RESPONSE LETTER NO. 2 TO REQUEST FOR INFORMATION

Project Title: **Improvements to SW 87 Avenue Bridge Over Canal C-100**
Project No.: **20220010**

SLOPE PROTECTION DETAIL

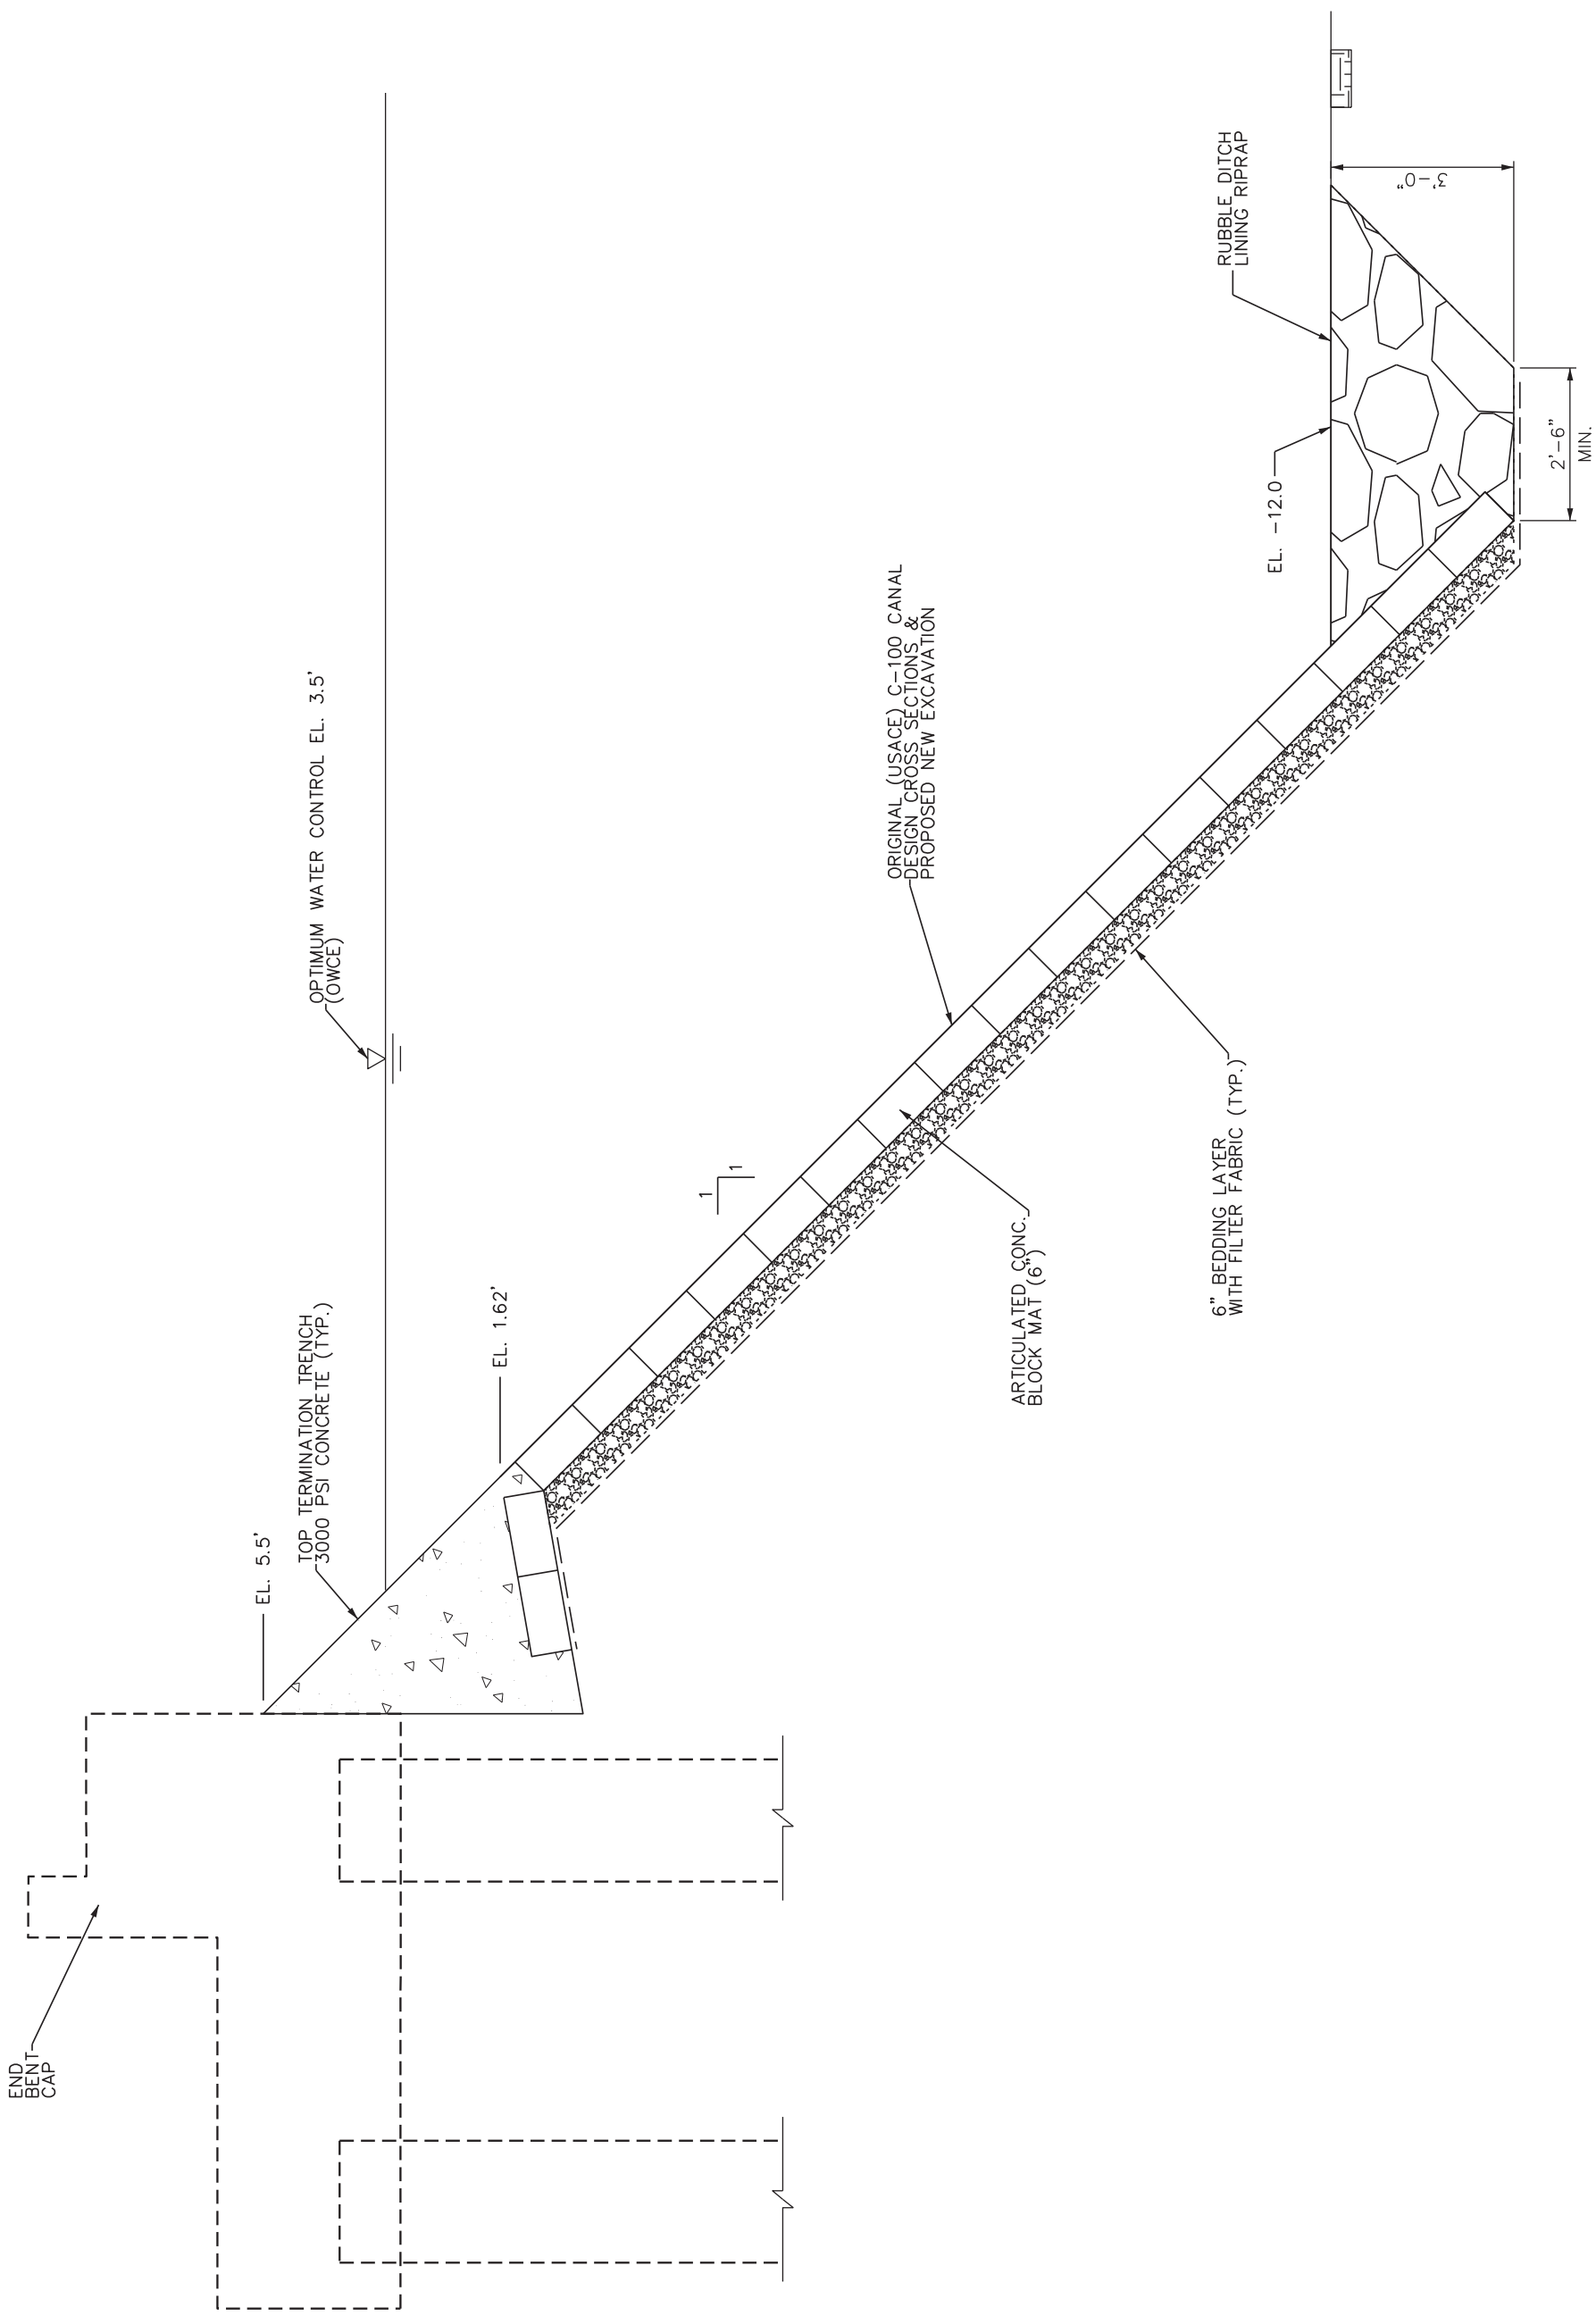
QUESTION: 1) The thickness of the Articulating Concrete Block Revetment System is to be 9", per bid items. However, the attached cross section shows the ACB system being 6" thick. Would you please clarify what thickness is to be used?

- The thickness of the Articulating Concrete Block Revetment System is to be 9", per bid items. However, the attached cross section shows the ACB system being 6" thick. Would you please clarify what thickness is to be used?

RESPONSE: 1) The thickness should be 6 inches. Please Refer to Addendum No. 2.
